**CAPITOL ZONING DISTRICT COMMISSION
STAFF REPORT 2023-018
9/21/23
JCL**

Location: 17th & Scott
Applicant: Cope Gracy for Riverwalk Properties, LLC.
Permit Types: Certificate of Appropriateness

Project Description: The applicant is seeking a Certificate of Appropriates to demolish an existing car wash and construct 12 new, single bedroom townhomes. The proposal is part of a larger development split by the CZDC boundary between Scott and Cumberland Streets, where 12 additional units are proposed. Those units within the CZDC boundary are labeled as Phase 2 on the site plans.

A7.1
COLOR ELEVATIONS

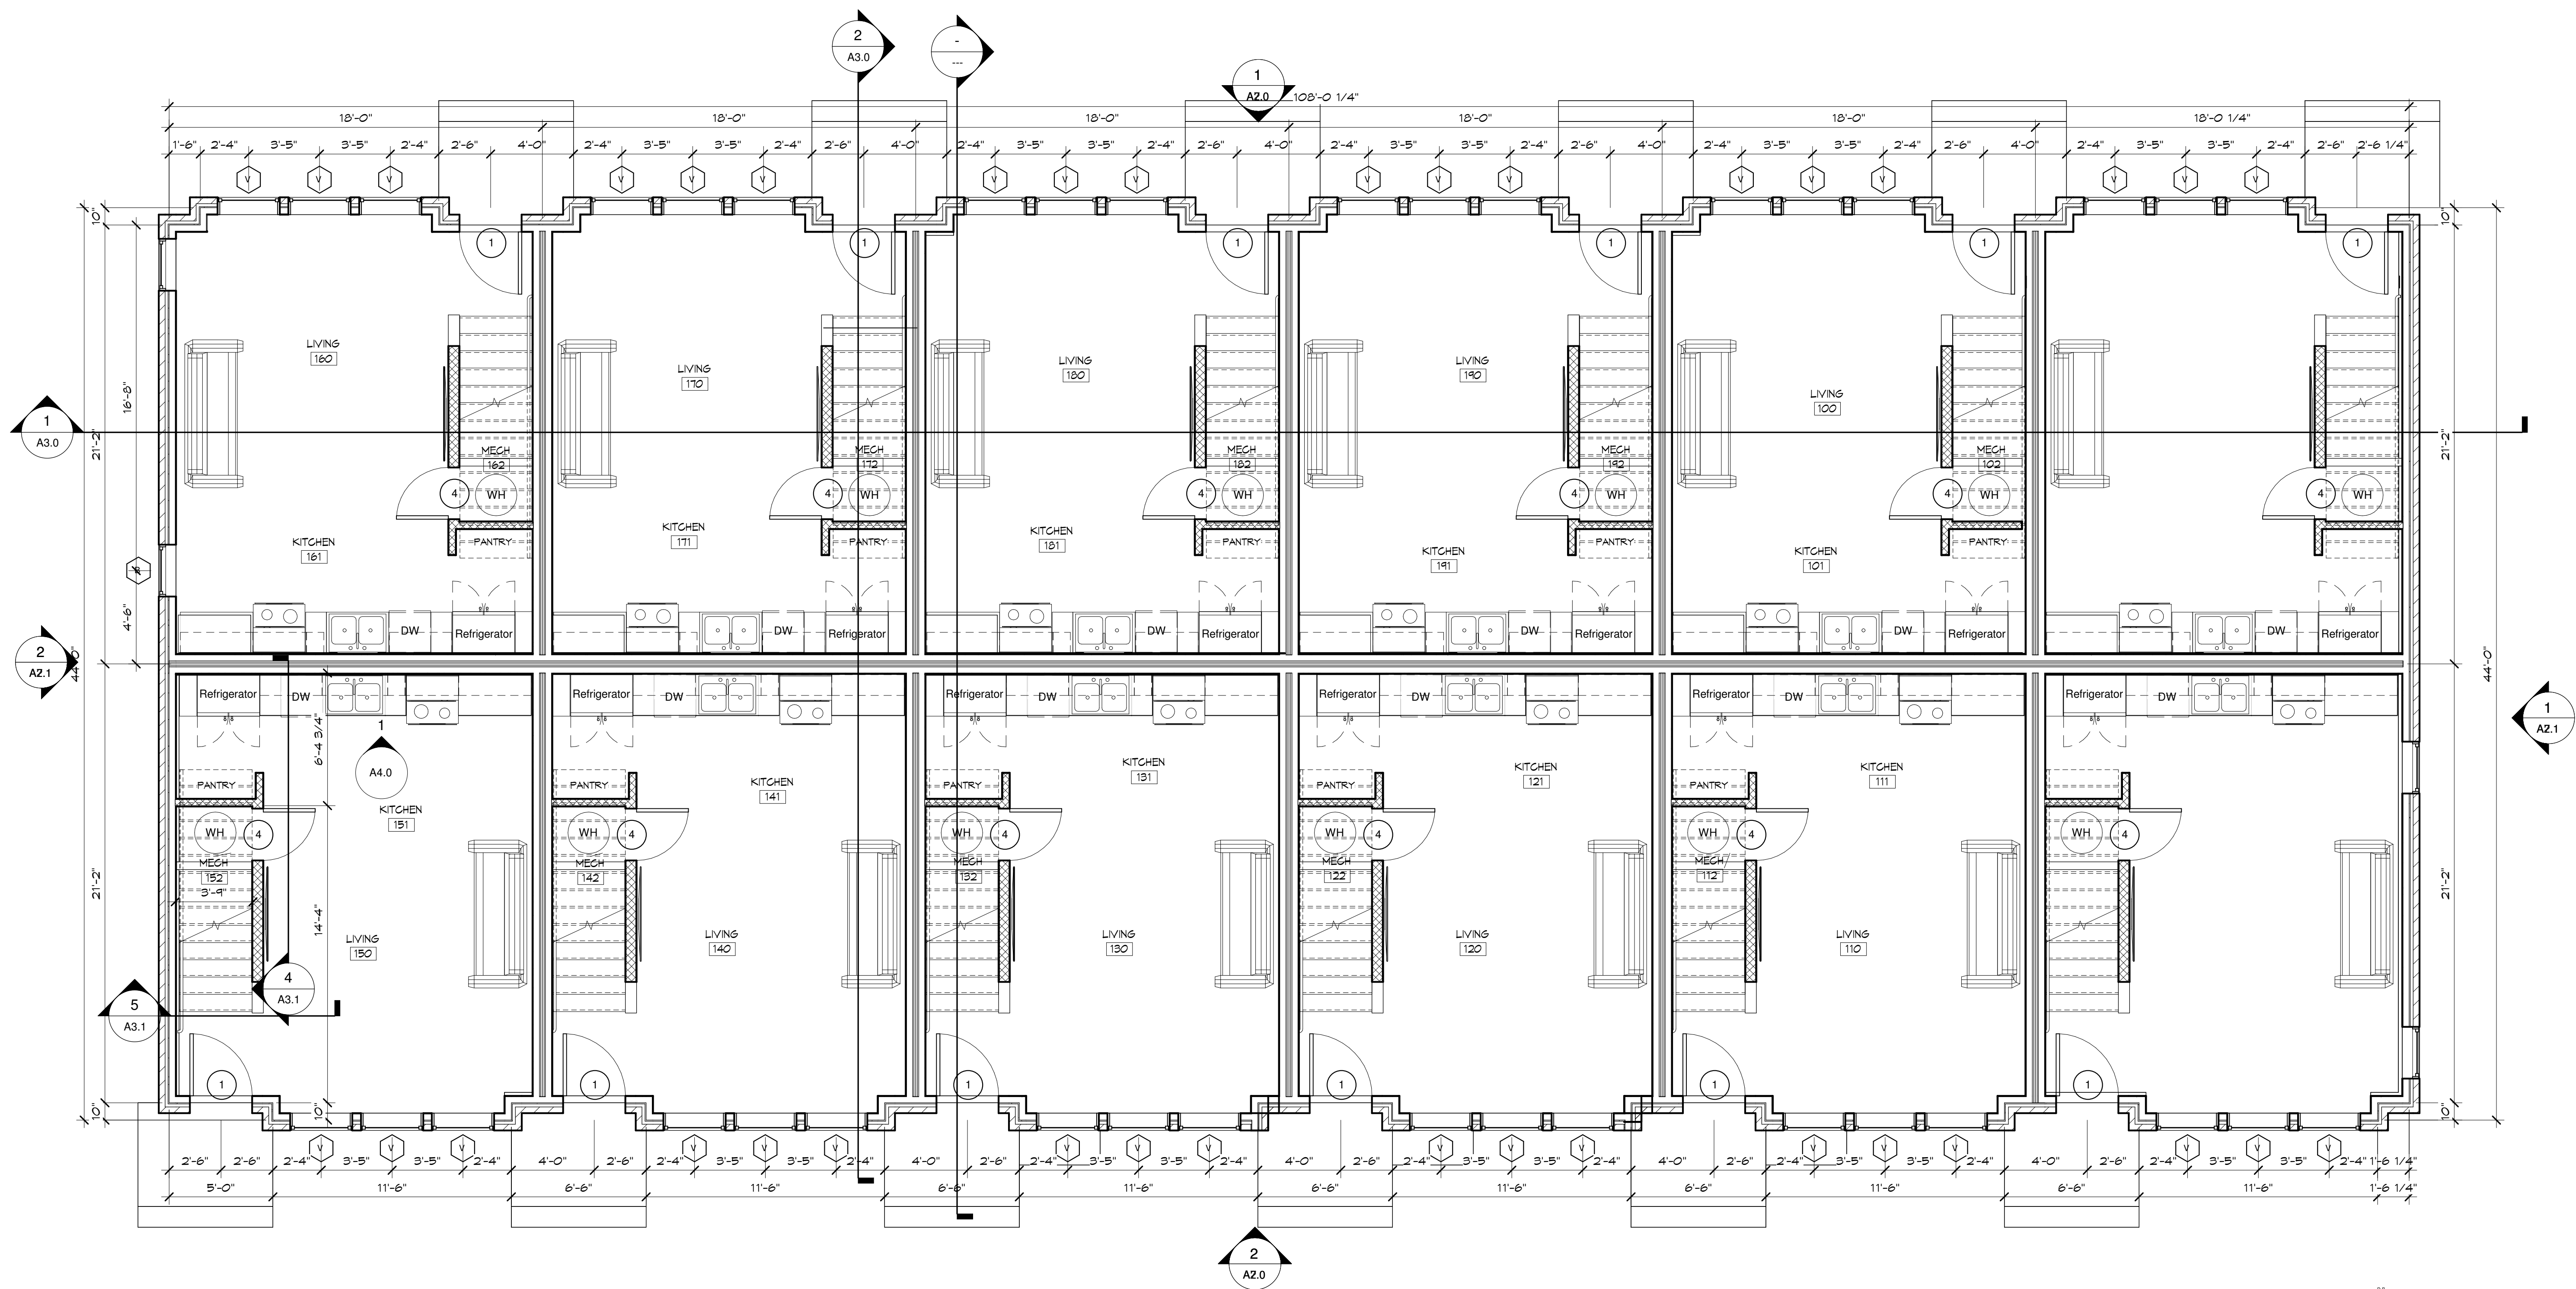
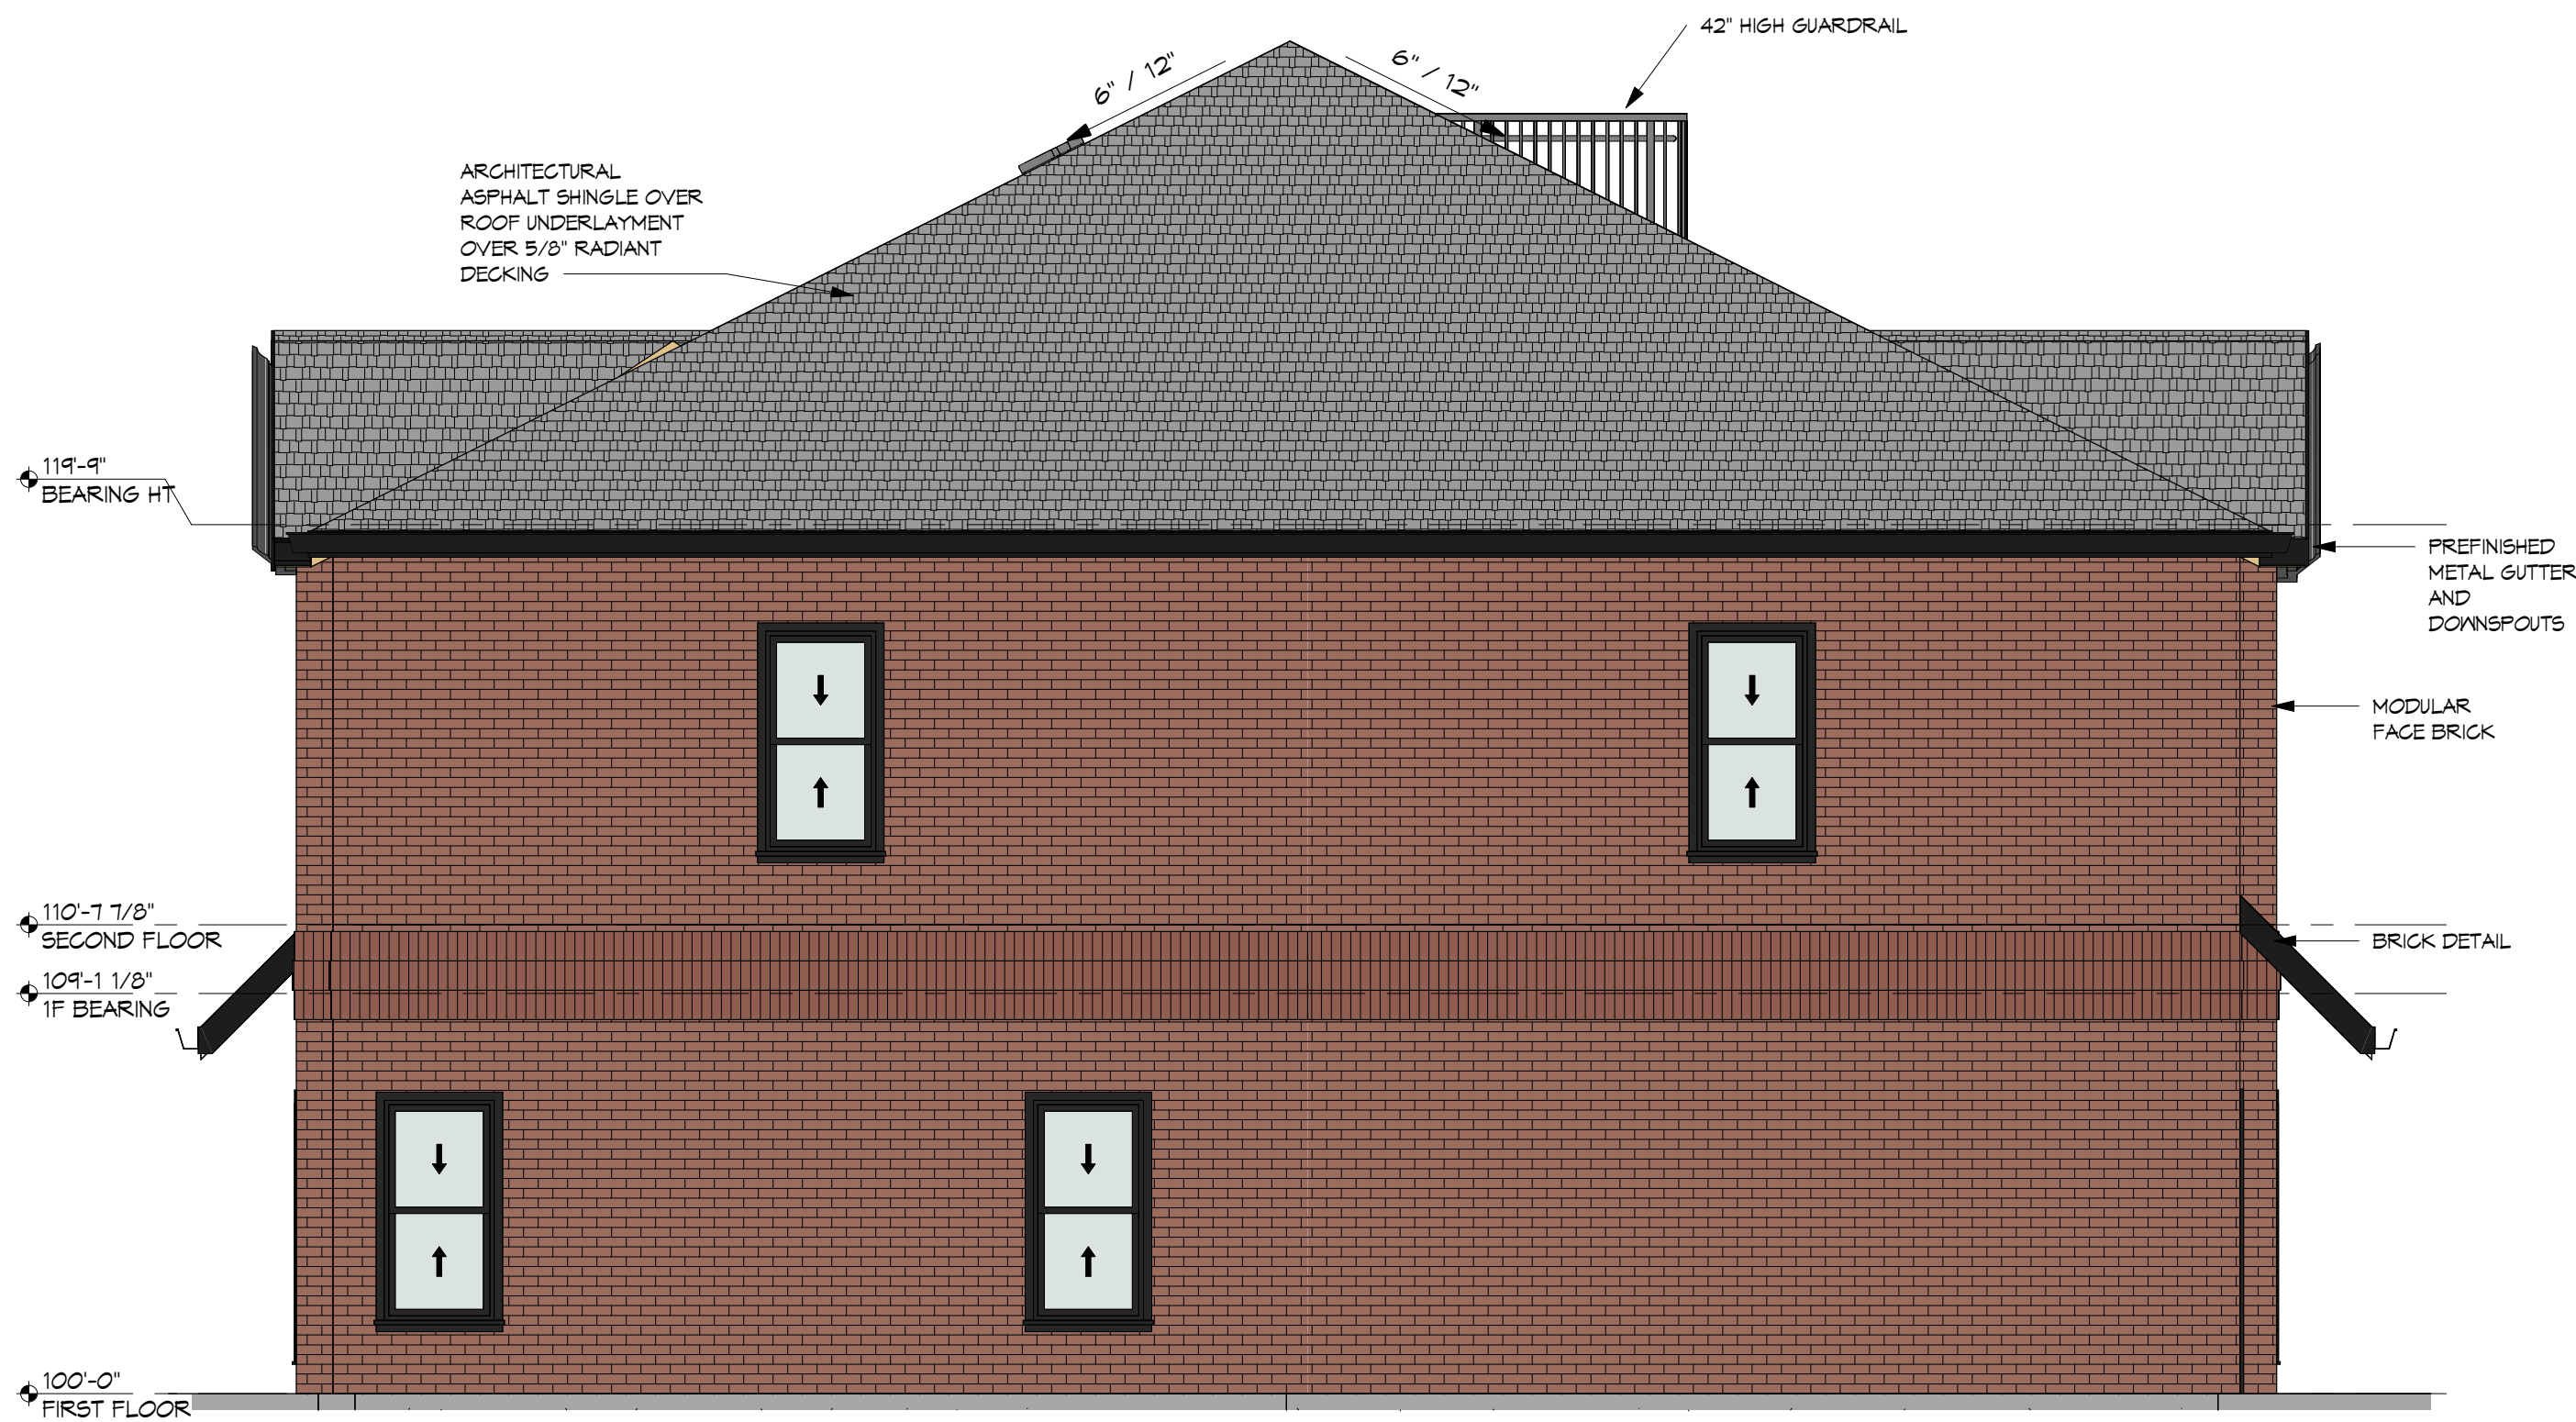
The expression of standard modules is maintained through the townhomes projecting gables, as well as differentiation in brick color. The soldier course also helps to break up the façade and provides other visual interest. Rooftop mechanicals will be screened from 17th street while both east/west facades are not void of any windows.

- First floor windows shall be divided with surface muntins.
- The peaks of the gables shall contain a vent or brick detail.
- To comply with CZ/ LR landscape requirements.

- 1) That all state and city codes be followed at all times.
- 2) That the property be maintained in a neat and safe condition at all times.
- 3) Phase two parking to include 1 reserved space for the disabled.
- 4) First floor windows shall be divided with surface muntins.
- 5) The peaks of the gables shall contain a vent or brick detail.
- 6) To comply with CZ/ LR landscape requirements.
